1 **POOL PUMP CONNECTED FUNCTIONALITY – DRAFT 2 CRITERIA**

2 **4 CONNECTED PRODUCT CRITERIA**

25
26 **Figure 1.** Connected Pool Pump System (CPPS)

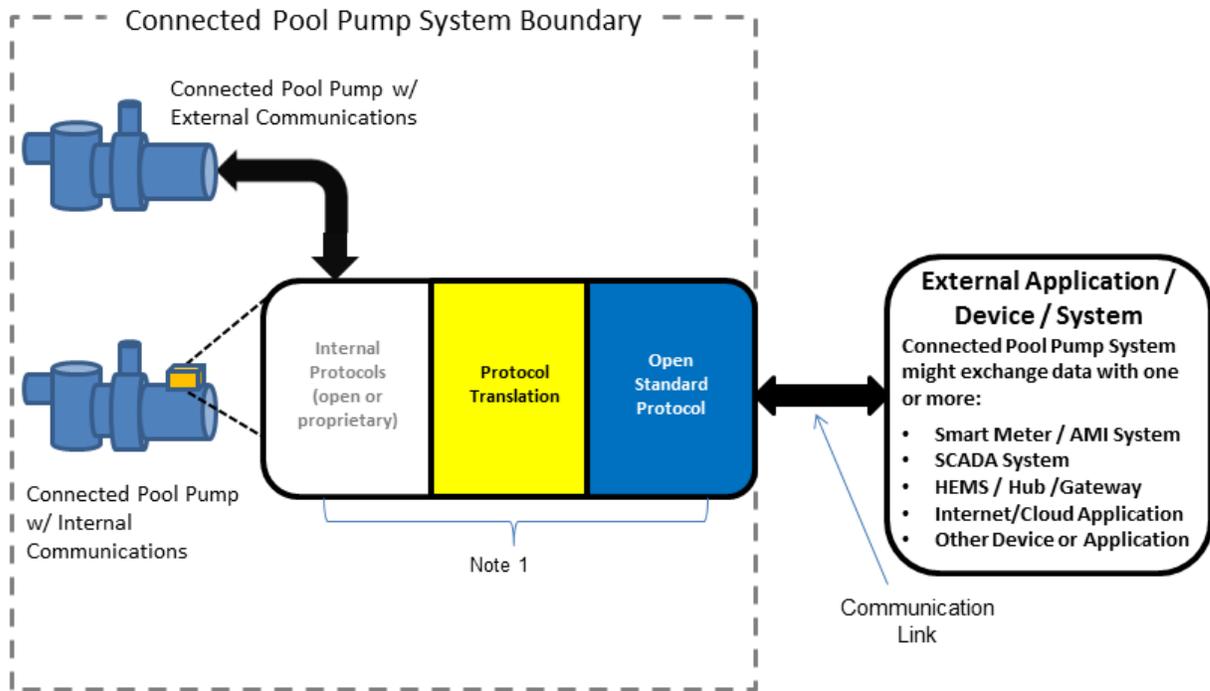
Note: In response to stakeholder feedback, EPA has revised Figure 1 to:

1. Include AMI and SCADA systems amongst the listed examples of external applications or services to which the product may connect; and
2. Clarify in the Note that the functional elements represented by the white-yellow-blue block may be implemented "either individually or together" in various physical or virtual element of the communication link.

The diagram is intended to simply define a CPPS for reference and not convey the requirements of subsequent sections. As such, it illustrates use of Open Standards for all external communications. EPA welcomes stakeholder comments on these clarifications.
